SERVICE BULLETIN No.1121

COACH MODEL	: C2045
BULLETIN TYPE	: Service Information
MANUAL & SECTION	: N/A
PARTS BOOK REVISION	: No
DATE	: October 27th, 2003
SUBJECT	: Alternator harness and lavatory slide valve heat shield interference possibility on coaches with Detroit Diesel engine
TERMS & CONDITIONS	: Van Hool/ABC will reimburse 30 minutes of labor per vehicle inspected upon receipt of a completed claim form on which has been specified "B+ alternator harness inspected as per Van Hool Service Bulletin No.1121."

Figure 1: Damage hazard at the lavatory slide valve heat shield (1)

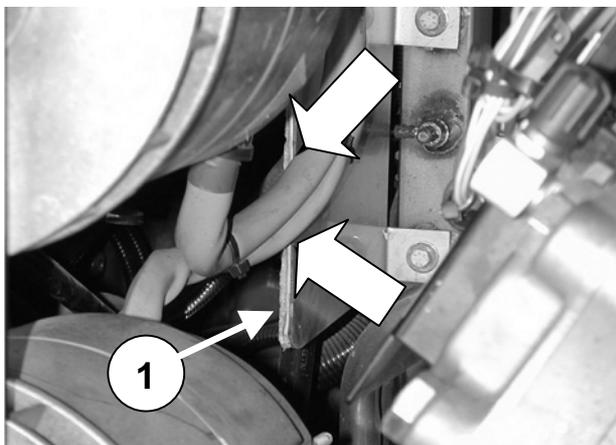
- 1) Open the engine compartment rear and side access doors.
Locate the lavatory slide valve heat shield.
- 2) Check the alternator B+ harness protection sleeve and cable for actual or potential damage as shown in 1, Figure 1.

Insulation damage: any damage to the protection sleeves and/or the B+ cable wire insulation should be repaired with heat shrink tubing.

Wire core damage: any B+ cable, of which the wire section has been reduced to less than 0 AWG (50 mm²) should be substituted. New cable should be protected with sleeve and secured with tie wraps.

CAUTION: Alternator B+ cables of which the core has been damaged, should be substituted in their entirety. No attempt should be made to partly replace these cables.

Figure 2: Proper routing of alternator cables and location of heat shield (HVAC compressor not shown):

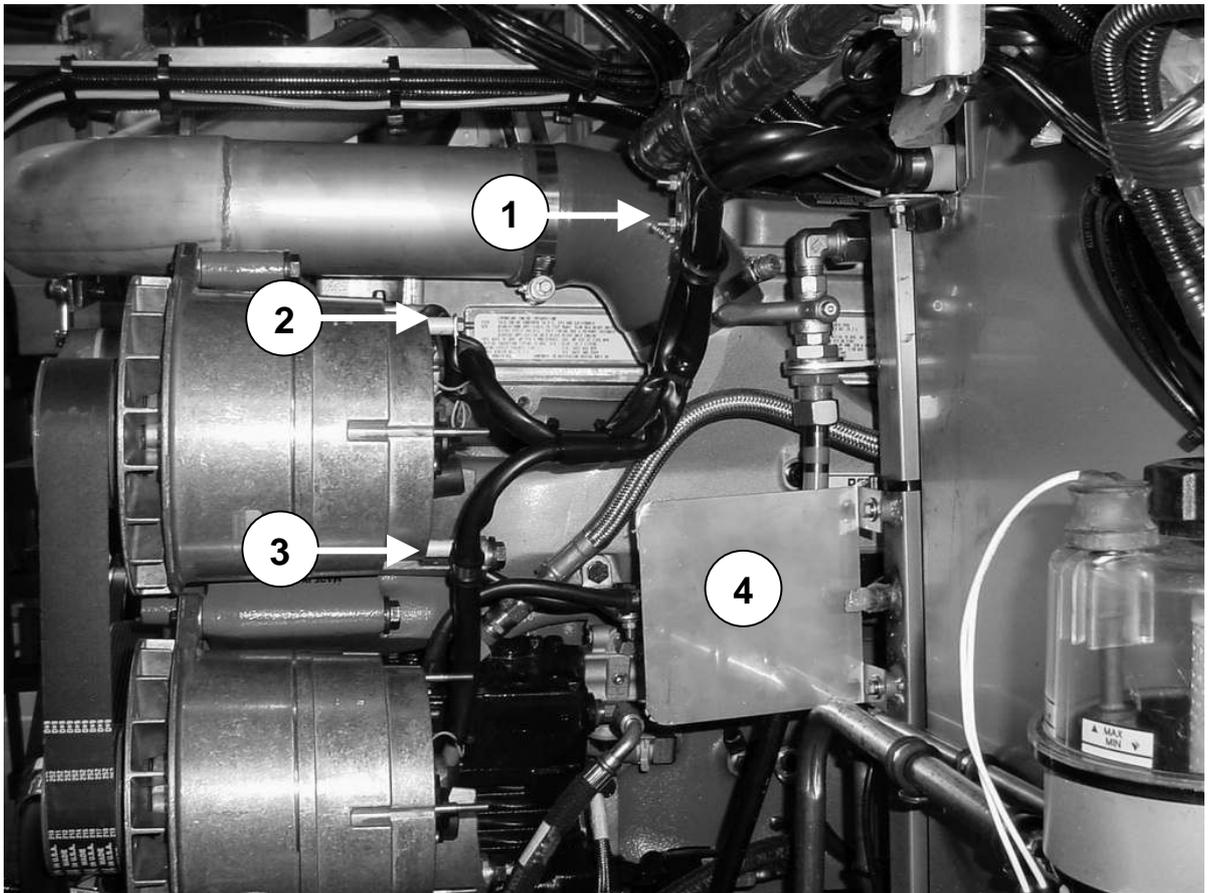
- 3) Check the B+ harness installation to comply with the recommended one shown in Figure 2. Cables should be installed free of strain and be supported only by rubber insulated clamps. Wiring should not be allowed to contact anything that might cause damage to it.

Note ample heat shield to alternator B+ cable vertical clearance.

Figure 3: Bending the heat shield to clear the wiring

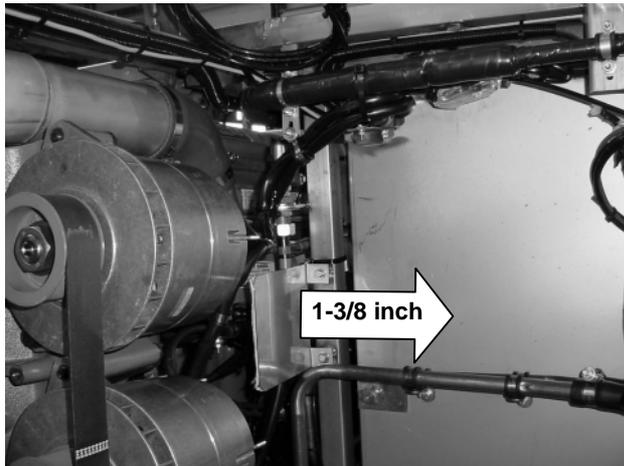
- 5) As a preventive measure to clear the alternator B+ harness, carefully bend the heat shield 1-3/8 inch (35 mm) towards the lavatory slide valve (see Figure 3).
